Product Change Notification (PCN)

PCN #: 6A-2023

Jun 19, 2023

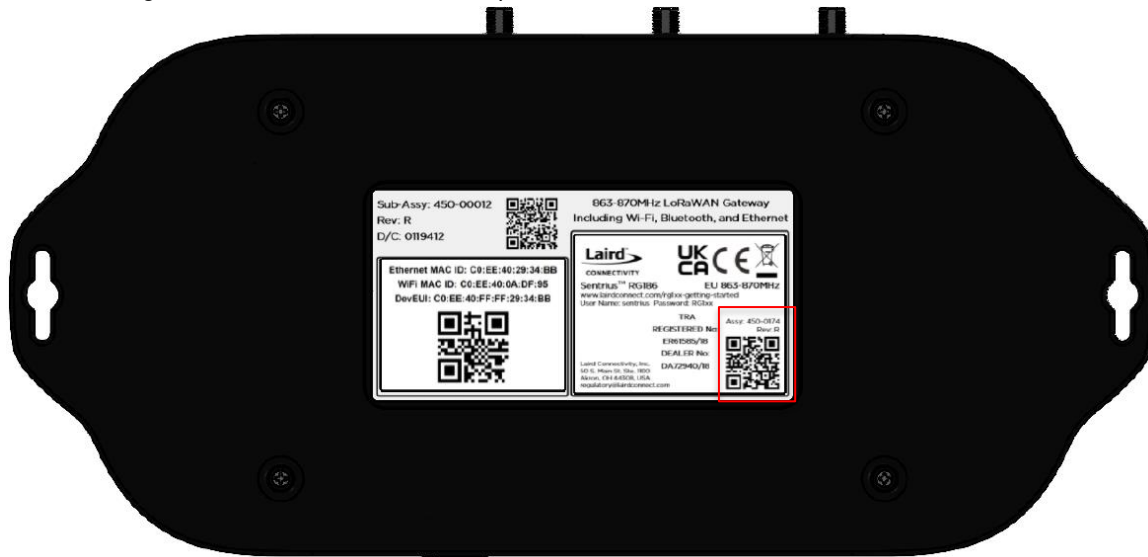
5.1 Assembly Part Number Changes (Product Back Label) Non-IP67

- Revision changes available as revision number printed and within the barcode.

5.2 Assembly Part Number Changes (Product Back Label) IP67

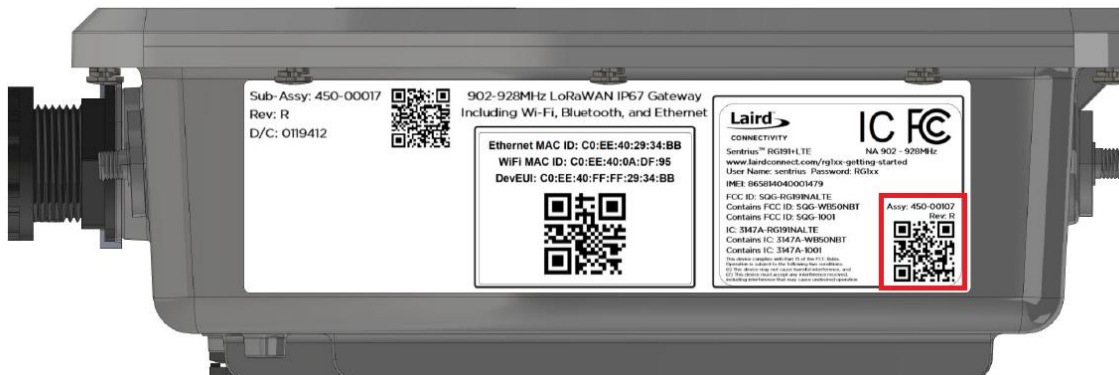
- Revision changes available as revision number printed and within the barcode.
